## **RUBY DIAMOND AUDITORIUM RENOVATION AND EXPANSION**

**Issue:** Vertical accessibility to all rows of seats in a tiered auditorium and the upper level parterres.

**REQUEST FOR WAIVER FROM ACCESSIBILITY REQUIREMENTS  
OF CHAPTER 553, PART V, FLORIDA STATUTES**

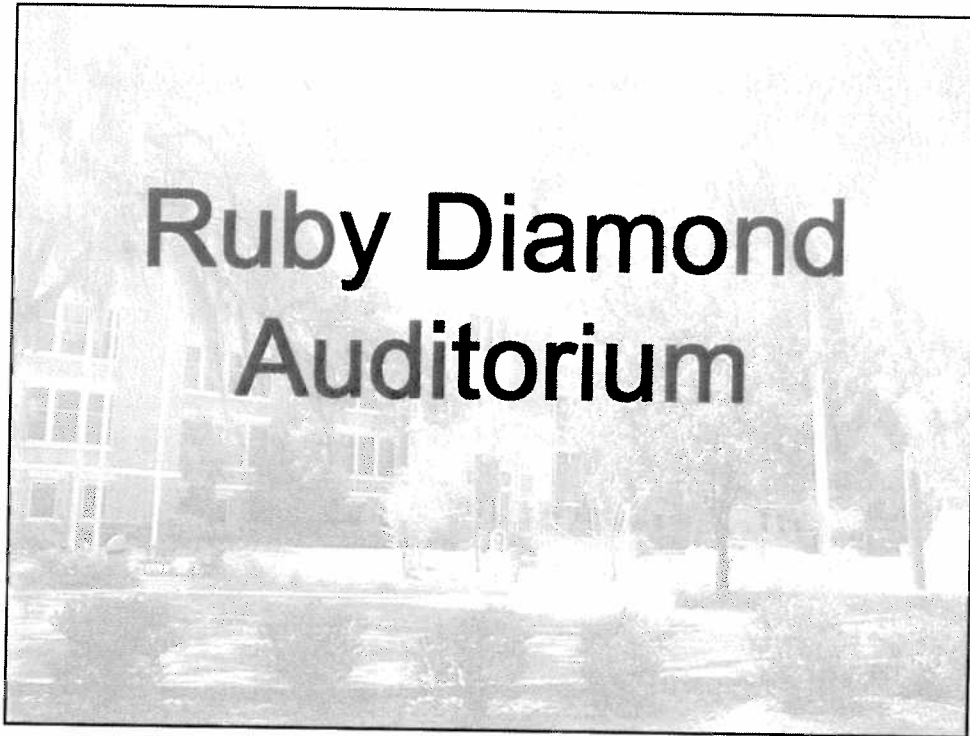
We are providing sketches and cost estimates for providing access to the lower balcony and upper boxes. The sketches illustrate the following construction elements required for the added balcony access.

- Second level North corridor connector for access to lower balcony seating platform (\$480,000)
- Wheelchair lifts for access to the house right upper box. (2 lifts @ \$16,000 each)
- Demolition of existing toilet room in Westcott building (\$6,500)
- Addition of new toilet room displaced by second level connector corridor. (\$45,000)
- Foundation and 2<sup>nd</sup> level connector at south side of building (Open -- \$230,000 / Closed & Conditioned Space -- \$515,000)
- Wheel chairlifts for access to the house left upper box (2 lifts @ \$16,000 each)
- Redesign of existing toilet room and addition of doorway for connection to south balcony and upper box. (\$35,000)

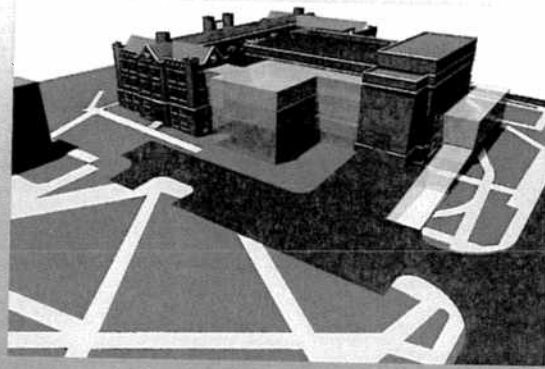
Early design scheme, discarded in favor of scheme with accessible drop-off
